**From:** [Han, James](#)  
**To:** [Downtown West Project](#)  
**Subject:** FW: Google EIR Letter  
**Date:** Friday, December 18, 2020 12:20:05 PM  
**Attachments:** [Google 2020Dec7 EIR Comments Dresden.pdf](#)

December 7, 2020

### **Downtown West/Google EIR Comments.**

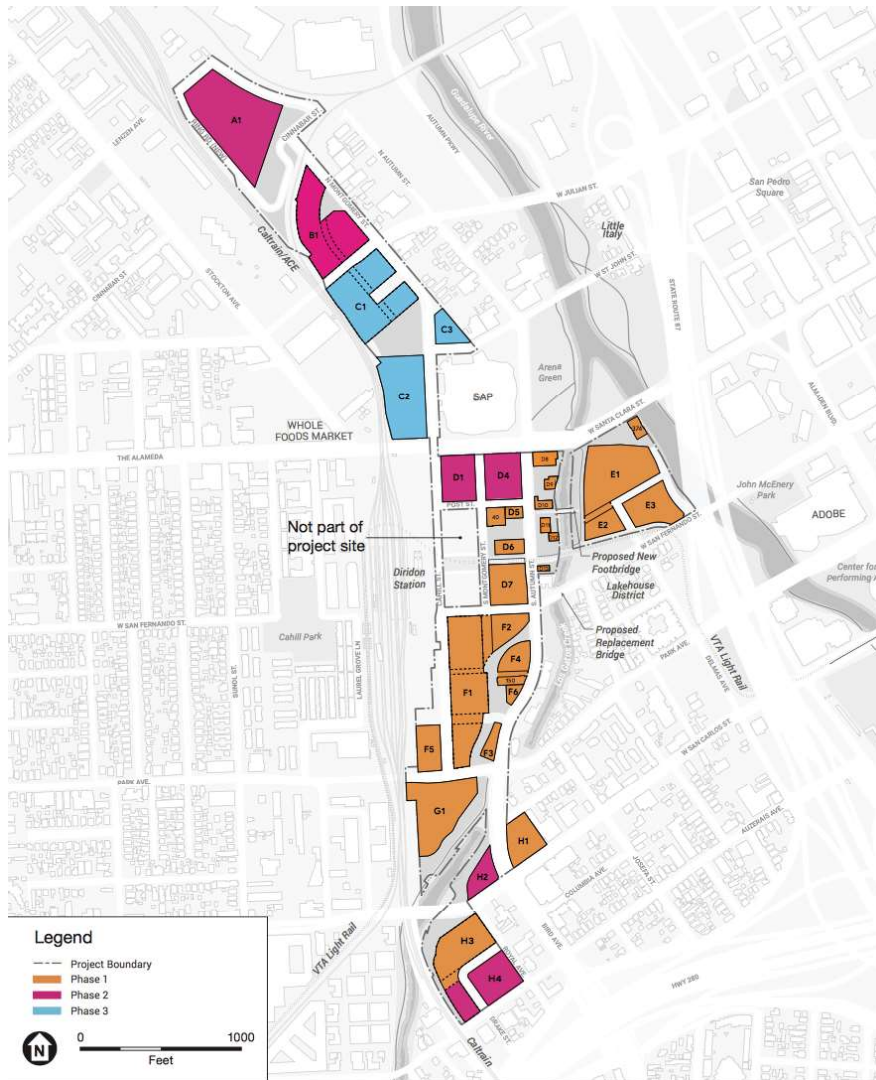
LU-1.9 Preserve existing Public / Quasi-Public lands **or include parks and open space improvements in redevelopment projects** in order to maintain an inventory of sites suitable for Private Community Gathering Facilities, particularly within the Residential Neighborhoods, Urban Villages and commercial areas, and to reduce the potential conversion of employment lands to non-employment use. **Public / Quasi Public lands located within the Diridon Station Area Plan may be re-designated to other uses provided that such uses will advance San Jose's employment growth or housing goals and include parks and open spaces within the development.**<sup>3</sup>

Please explain the intention of this amendment. What, if anything, does this have to do with the Fire Training Center? Does this amendment grant permission for current parks to be destroyed for a private community gathering spaces such as a church, a new hockey stadium, or a music amphitheater? Would park conversion rules (ie requiring an election) still apply?

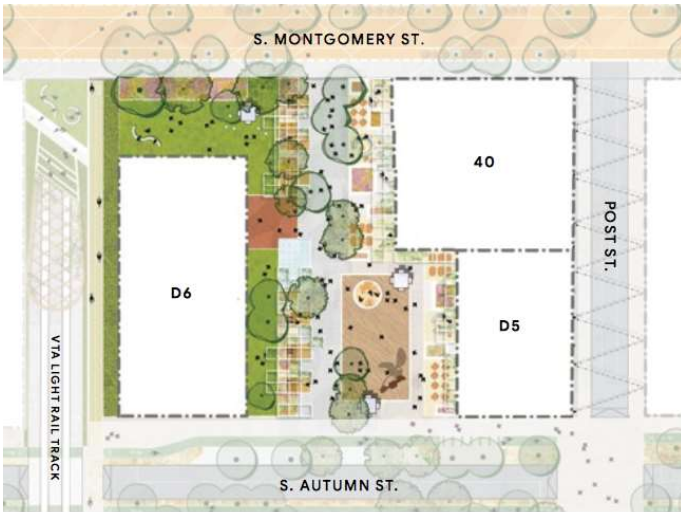
The **privately owned publically accessible parks “may have more limited hours of public access than City-dedicated parks”**<sup>11</sup> Nowhere is there a published statement of access. Will the public be allowed one day per week? One day per month? One day per year—like Grammercy Park in New York City? Will this property be closed for Google events, such as conventions or sales trainings or retreats? Who decides when it is open or closed? Who decides when it is *too*

*limited?* How does limited access promote equity, a key principle of both San Jose's General Plan Park policies and *Activate SJ*?
